IMPORTANT SAFETY RECALL CAMPAIGN ANNOUNCEMENT
NHTSA Recall Campaign #04V-363

RECALL CAMPAIGN

#9901053 / 04V-363

Subject:	Water Heater 120-volt wire connections		
Units Affected:	2004 Jay Feathers with optional GC6AA10E DSI/Electric Water Heaters		
Action Required:	Inspection and stripping of 120-volt wire insulation.		
Job Operation Code:	9901053		
Series Code:	Inspection	RC005	
	Inspect/repair	RC013	
Repair Time:	Inspection	.1 hrs.	
	Inspect/repair	.5 hrs.	
	 NOTE: Authorization is needed to replace any Atwood water heater part.		
Kit Part Number:	N/A		
Parts Kit Includes:	N/A		
Tools Required:	<ul style="list-style-type: none">• Square tip bit• Screw gun• Wire strippers• Measuring tape		
Additional Requirements:	Yellow wire nuts

Fig. 2

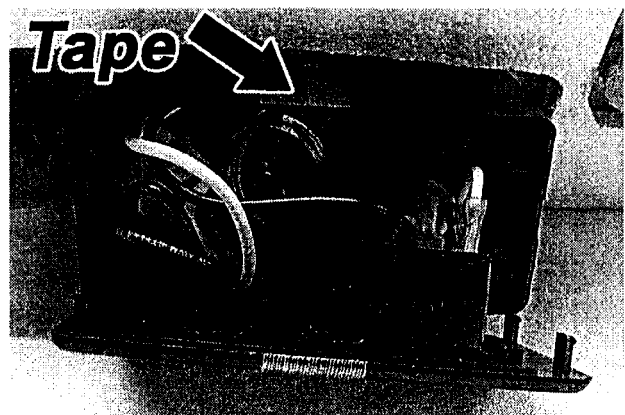
3. Drain all water from the water heater.
4. Disconnect the bottom water line that is routed across the water heater electrical junction box cover.
5. Cut the tape that holds the electrical junction box cover on the back of the water heater. Remove the cover. (Fig 2)
6. Pull the 120-volt wires out of the water heater electrical junction box (Fig 2).

Fig. 4

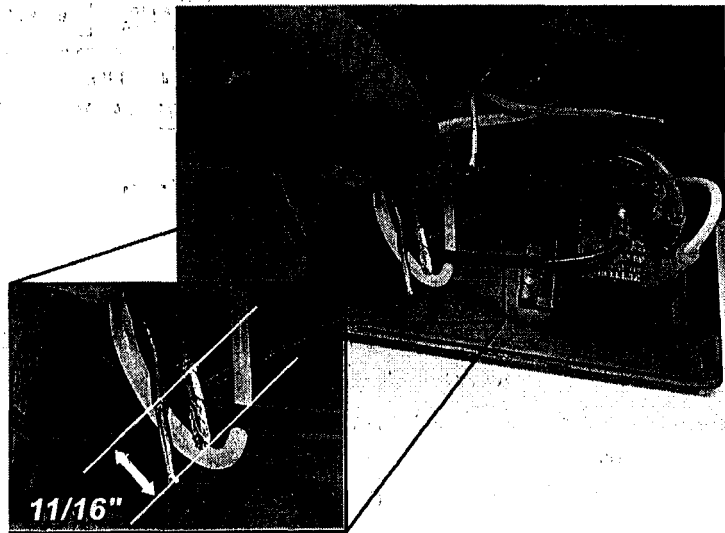
8. Cut off the yellow 120-volt wire nuts from each of the black, white and ground wires. Discard all original yellow wire nuts (Fig. 3).
9. Re-strip each wire to 11/16-inch long (Fig. 4).

10. Hold the white 120-volt wires to be spliced together parallel with the stripped ends even. Apply the wire nut and twist on until tight (Fig 4).

11. Hold the black 120-volt wires to be spliced together parallel with the stripped ends even. Apply the wire nut and twist on until tight (Fig 4).
12. Hold the green and bare copper 120-volt wires to be spliced together parallel with the stripped ends even. Apply the wire nut and twist on until tight (Fig 4).

(N) NOTE: Wires that are to be spliced together must be stripped at equal lengths. Cut back the wire if they are discolored or damaged by heat exposure.

(N) NOTE: Trim the ends of all stranded wires to ensure that no strands are longer than 11/16-inch.

(N) NOTE: Do not pre-twist the 120-volt wires before applying the wire nut.

Fig. 5

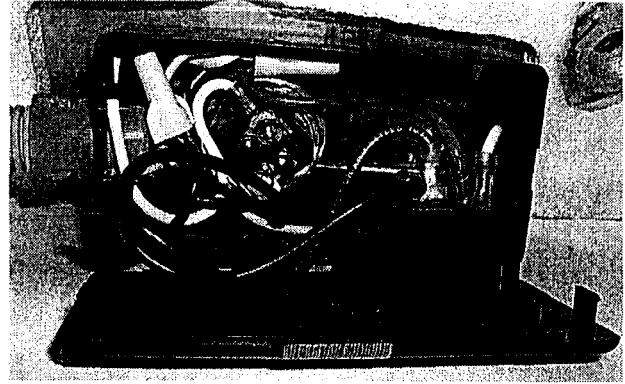
13. After all wires have been re-connected insert them back in the electrical junction box on the back of the water heater. Assure that all wires and connectors are positioned away from the heating element terminals (Fig. 5).

**WARNING:** When placing the wires in the junction box, avoid making contact with the terminals of the heating element. Allow space for the relay.
